**Report: TAB Report**  
**Function: Test, Adjust, & Balance**  
**Date: 11/11/2024**  
**Completed By: National TAB**

**PROJECT**  
**10-21-24 WAWA #5413 SARASOTA, FL**

**Issue Name :** RTU turning vane installation  
**Description :** The turning vanes located in the supply drops of the RTUs are not fully installed, sitting loose inside the duct. Recommend installing.  
**Created By :** National TAB                      **Assigned To :** National TAB - Mark Johnson  
**Status :** Closed  
**Priority :** InfoOnly                                      **Asset Tag :**  
**Originated Date :** 06/30/2024 - Mark Johnson - National TAB

- RTU turning vane installation

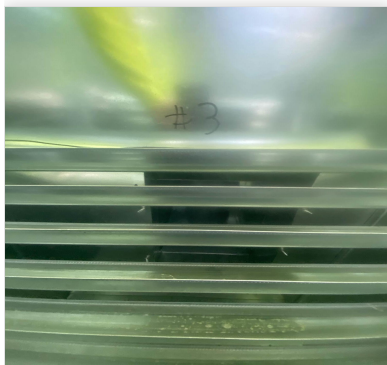
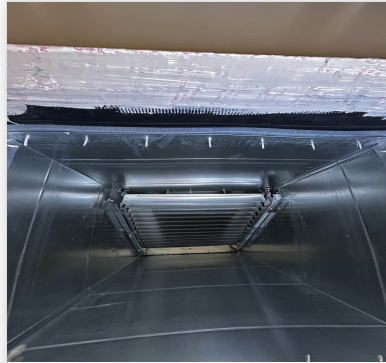
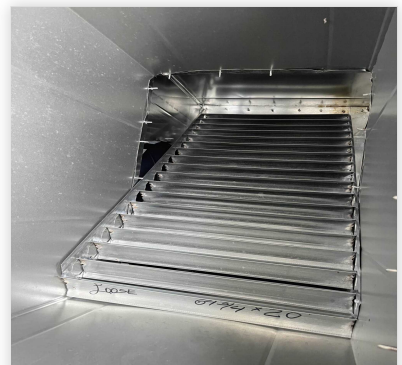
- Issue is still present. Turning vanes appear to be secured to duct but do not transition the air around the 90 degree turns for all units.

- Turning vanes are confirmed to be screwed into the ducts. However, they do not appear to smoothly transition the air around the 90 degree turns. Recommend EOR review.

- **11/11/2024 National TAB - Will Turnbough**
  - General contractor sent images showing positioning of the turning vanes. The location of the turning vanes is unorthodox as they are not located in the elbow of a 90 degree transition however they do help to guide air into the branches on the plenum drop. Airflow is within design so no further changes are necessary.
